D/DRC Case

1500 Main Street

**DESIGN/DEVELOPMENT REVIEW COMMISSION
DESIGN REVIEW DISTRICT
HISTORIC/CONSENT AGENDA
EVALUATION SHEET
Case #3**

NATURE OF REQUEST: Request for Certificate of Design Approval for exterior changes and preliminary certification for the Bailey Bill

SYLVAN BUILDING DORMER ONE

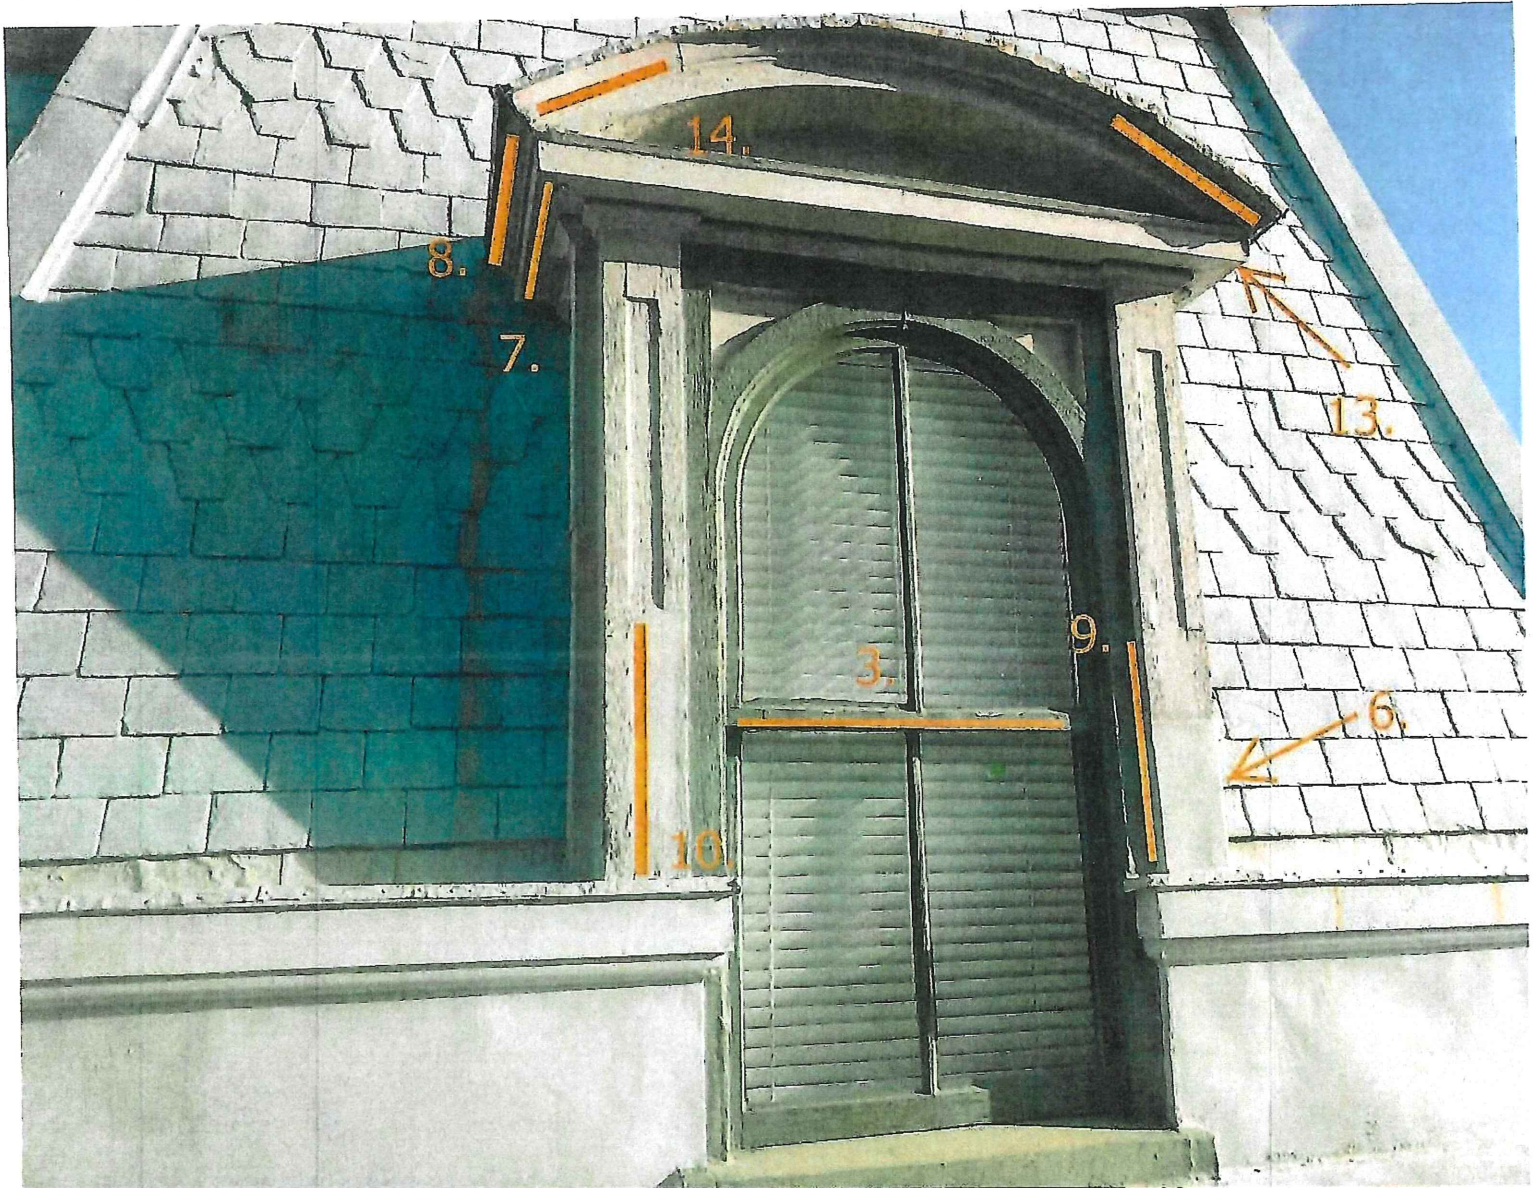
Areas lined with red are rotten and needs replacing.
Numbers above correspond with detail picture

SYLVAN BUILDING DORMER TWO

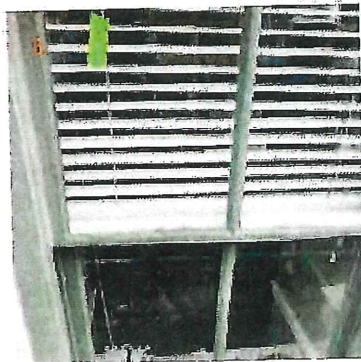
METAL PATCH

Areas lined in red are rotten and it is recommended that they be replaced. Length of red line is how much needs replacing.
